Palisades Nuclear Plant
Docket 50-255
License No. DPR-20

Response to Requests for Additional Information Regarding License Amendment
Request: Removal of TSP from Palisades Containment

ENCLOSURE 1
RESPONSE TO REQUEST FOR ADDITIONAL INFORMATION
PALISADES NUCLEAR PLANT

FIGURE 1

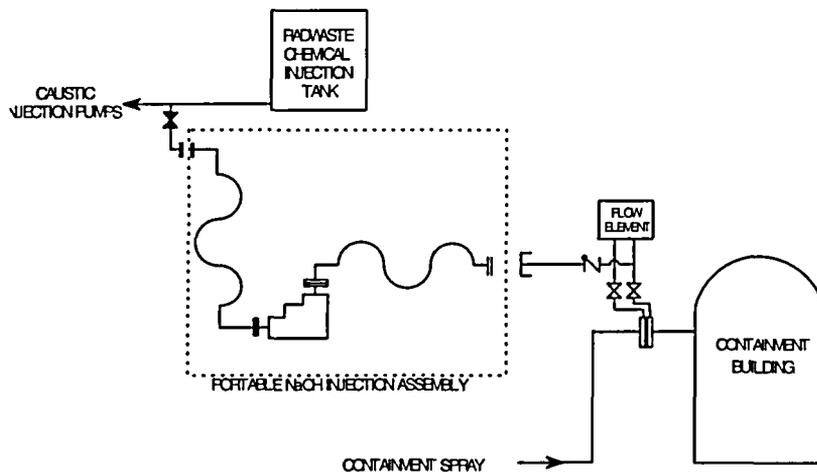
1. *In the event of a loss-of-coolant accident (LOCA) with recirculation, sodium hydroxide (NaOH) will be injected via the containment spray system within 7 days to control the containment pool pH. Provide an overview of the injection method, including NaOH spray duration, pH of the spray, and the range of containment pool pH once all NaOH has been injected. Discuss any assumptions.*

1. PNP intends to use a portable injection assembly to transfer the required amount of NaOH into containment upon demand. Figure 1 below provides an overview of the injection method. The portable assembly transfers the NaOH from the tank of the radwaste chemical addition system to the injection port on an instrument flange of the containment spray system. The NaOH can be injected into either one of the two redundant containment spray headers. Two portable injection pump skids are planned to be available at the plant site. The pump is planned to be powered from a safety related source and is to deliver a flow of 2.5 gallons per minute.

Under the design basis loss of coolant accident scenario, a nominal 380 gallons of 25% NaOH solution is to be injected into containment via the spray flow. The duration of the NaOH injection operation is estimated to be two and one-half hours. The design of the NaOH injection system is to raise the containment sump pH to between 7 and 8 as measured at 25°C, based on an initial spray flow pH of 4.5.
